ECONOMISER ASSEMBLY

DRG NO : EC-15-GA-001

BOM CHECK SUMMARY

Drawing : drawing.pdf (Rev C)
BOM : bom.xlsx (Rev B)
Input : vector PDF
RUN RELIABILITY : HIGH

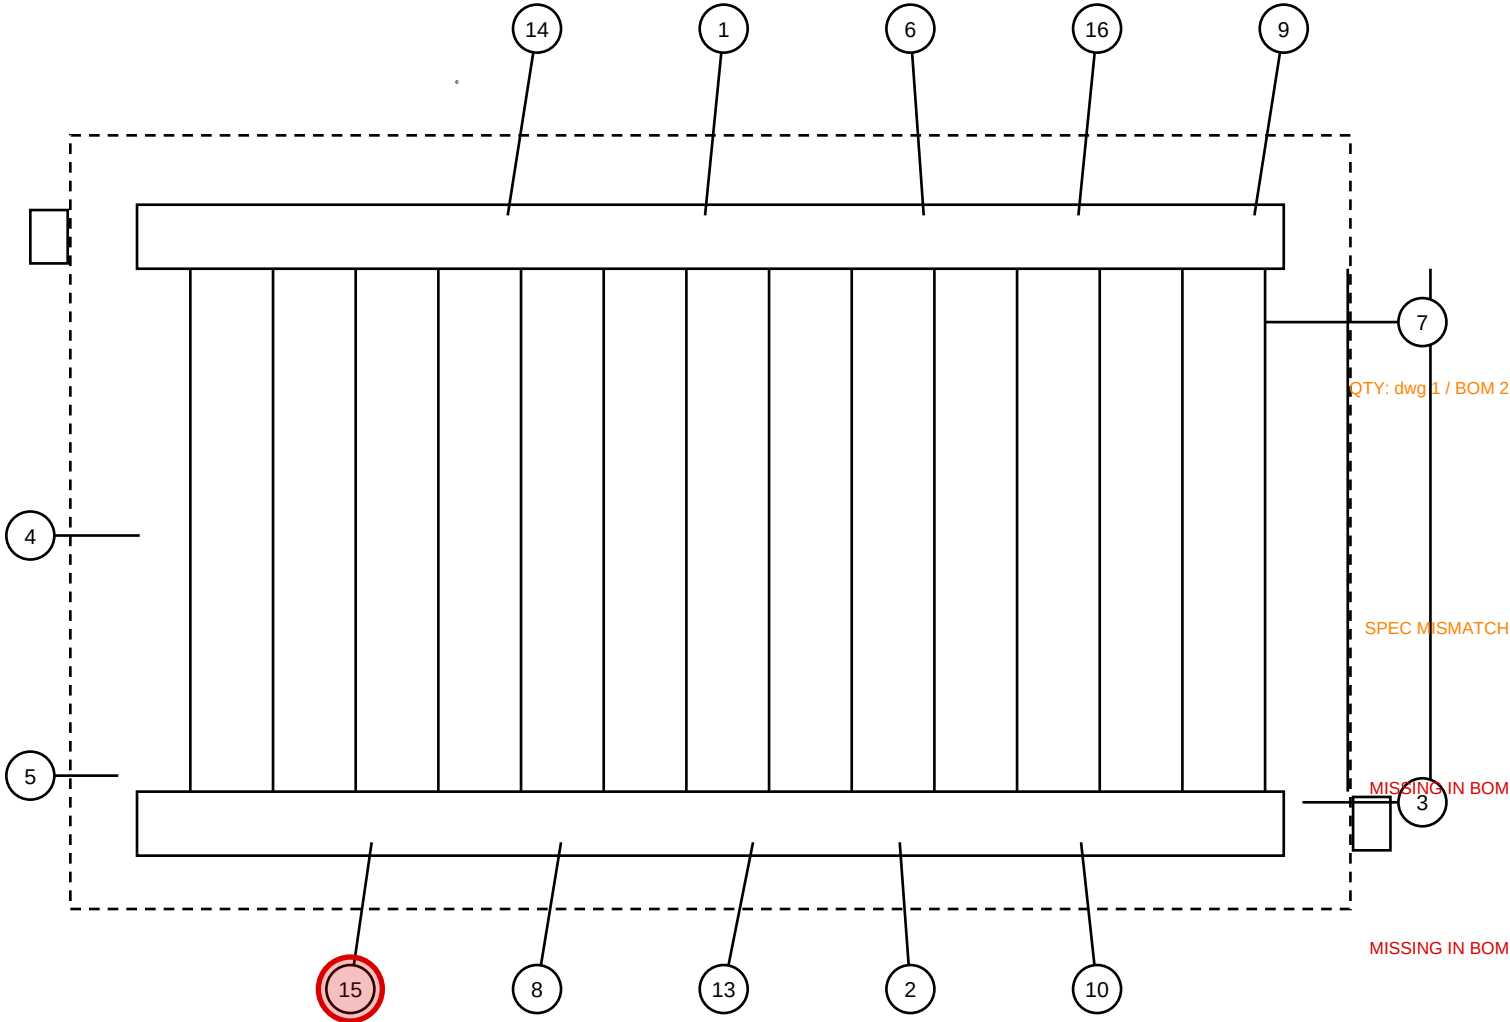
Findings: extra 1, omission 2, quantity 1, revision 1, spec 1

[RED] Item 11 'GASKET 200 NB CL.150' (qty 2) is on the drawing but has no BOM line
[RED] Item 15 'NAME PLATE' (qty 1) is on the drawing but has no BOM line
[ORANGE] Item 1: quantity differs (drawing 1, BOM 2)
[ORANGE] Item 7: specification mismatch - dimension: drawing ['200'] vs BOM ['250']
[ORANGE] Revision mismatch: drawing is Rev C, BOM is Rev B
[YELLOW] BOM row 23 'Hand rail, 42 NB' has no matching item on the drawing (extra, or from another revision)
